Bicycle and Pedestrian Advisory Committee (BPAC) Questions April 24, 2024

6.1 California Street Project Update

6.2 Active Transportation Plan Scoring Criteria

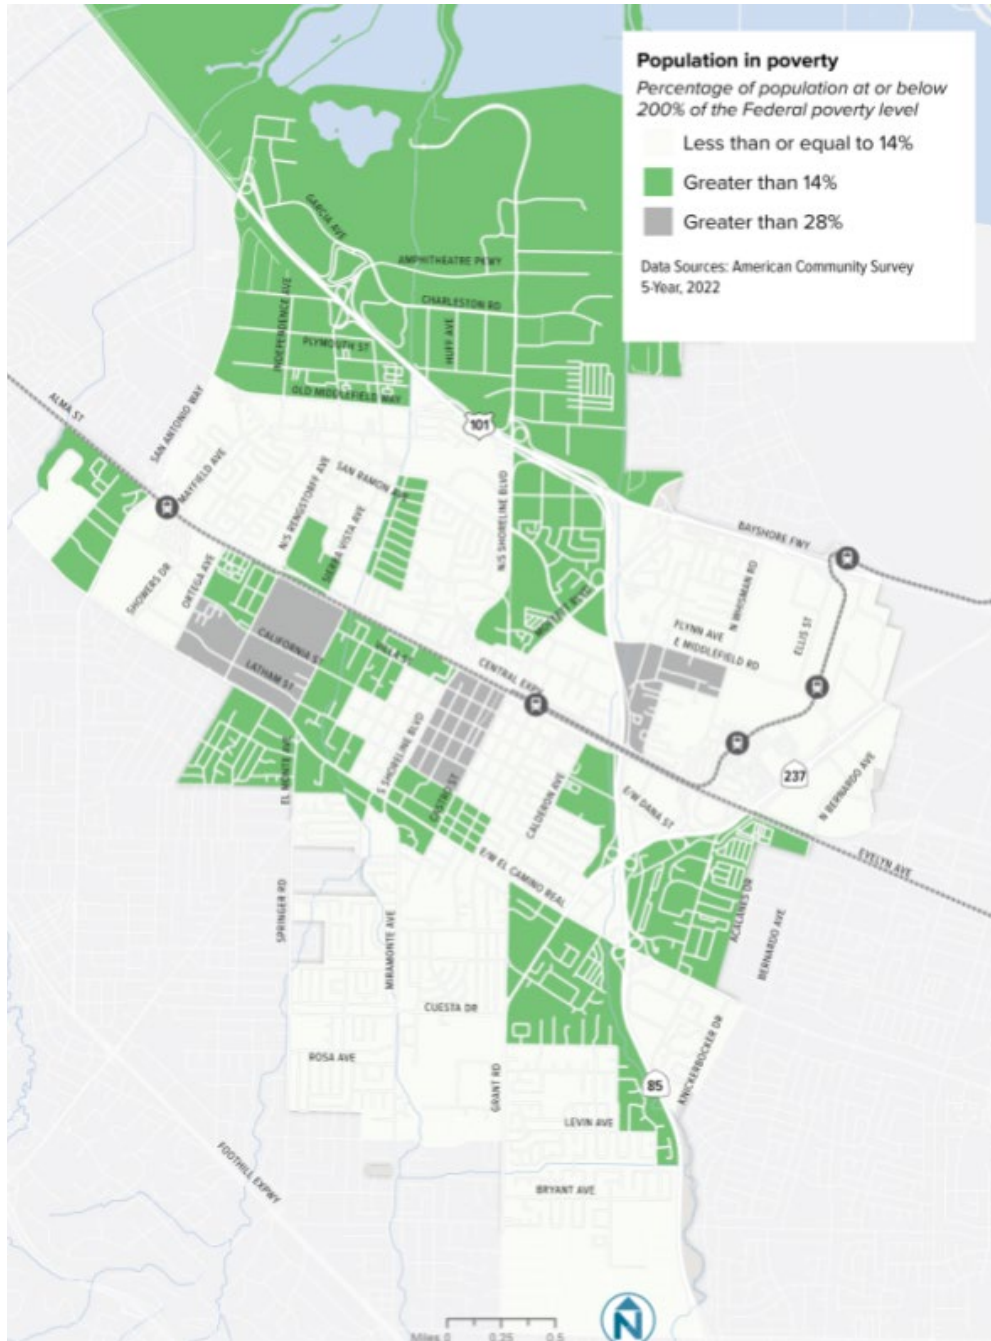
22. Question: Is there a map showing the 14% and 28% neighborhoods for Mountain View (Table 1).

Answer: Yes. See below.
